Staff Report to the **Zoning Administrator**

Application Number: 08-0139

Project Description: Proposal to construct a 2nd-story addition to include 3 bedrooms, two bathrooms, closets and a stairway to an existing 1-story single family dwelling with a basement to result in a 2-story, 5 bedroom, 6 bathroom single family dwelling. The project requires a Coastal Development Permit and a Residential Development Permit to construct an addition greater than 800 square feet to an existing nonconforming structure.

Denial of Application 08-0139, based on the attached findings and conditions.

EXISTING STREET VIEW

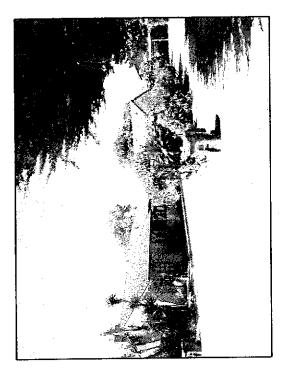
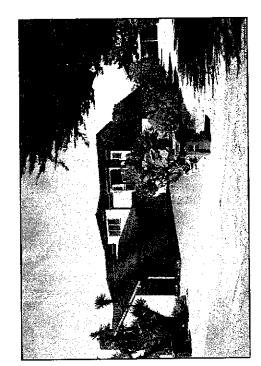
The building located on the north side of the subject property is a one story structure approximately 1900 square feet in size. The impact of the proposed second story massing on this structure is significant. The design does not provide enough visual relief on the flat wall plane created by the second story and presents a relatively severe façade to the property located to the north.

While a short section of wall is extended one foot farther into the side yard than the rest of the wall, this design element does little to break up the overall mass or provide any real visual relief of the two-story wall.

The proposed second story bay window adds to the mass facing the beach and accentuates the look of three stories (the bottom floor is a story as it does not qualify as a basement by ordinance definition (13.10.700 D-Basement). The bay window extends four feet farther than the existing building. The public view from the beach is of a three story, twenty four foot high structure.

The designer has a variety of options to reduce the effect of the addition on the structure and the view from the beach including additional articulation, which would lessen the impact to the point that greater compatibility is achieved. If the applicant wishes to pursue design modifications, a continuance may be requested during the hearing.

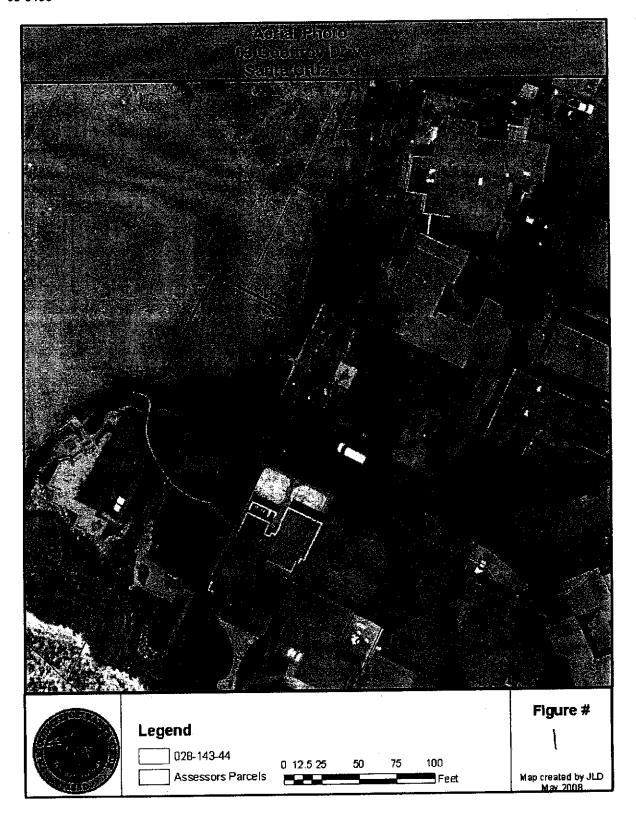
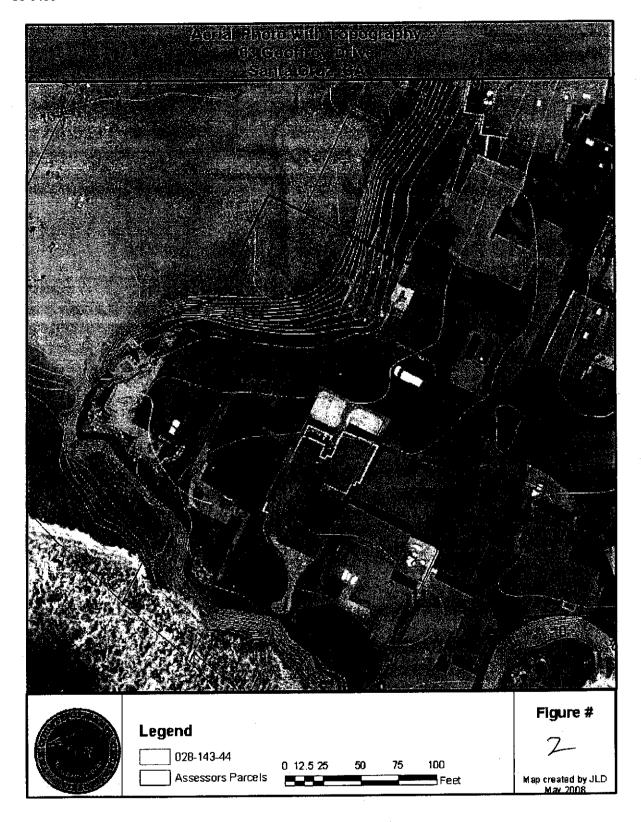
The parcel is located on the coastal bluff (figure 1), along the east side of Black's Beach in Santa Cruz, CA. The coastal bluff extends approximately 30 feet down to the beach at this location (figure 2). The existing home is located approximately 27-31 feet from the edge of the bluff. A concrete patio is approximately 20 feet from the edge of the bluff. The proposed 1,479 square foot room addition will be constructed on the second floor over the existing northern side of the home and consists of 3 bedrooms, 2 bathrooms and a stairway. The existing home is 2,315 square feet with a 678 square foot basement.
